Cimarron Environmental Response Trust	
	Radiation Protection Plan	
Document No. RP-001	Rev. 0 [DRAFT A]	Effective date: 4/1/2011
		Page i

Cimarron Environmental Response Trust	
	Radiation Protection Plan	
Document No. RP-001	Rev. 0 [DRAFT A]	Effective date: 4/1/2011
		Page ii

Figure 3-1

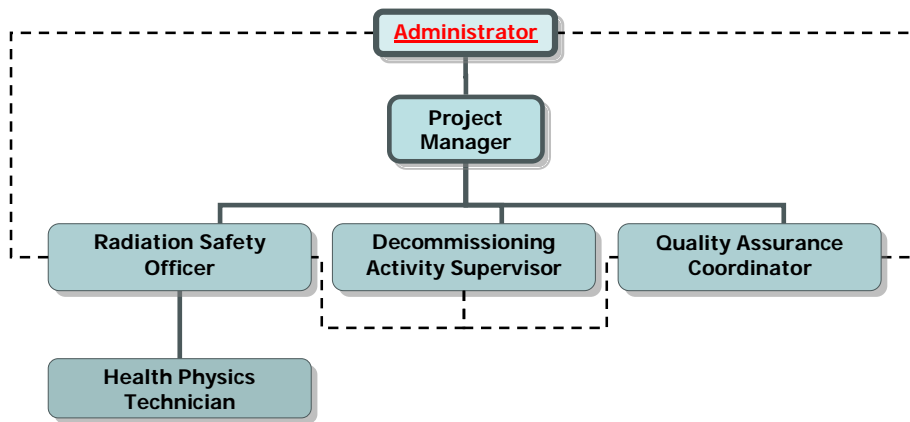
Comment [JJM2]: Change made to capture Cimarron Environmental Response Trust organization. Other conforming changes made throughout the RPP.

~~Cimarron Corporation~~ The Cimarron Environmental Response Trust Organization
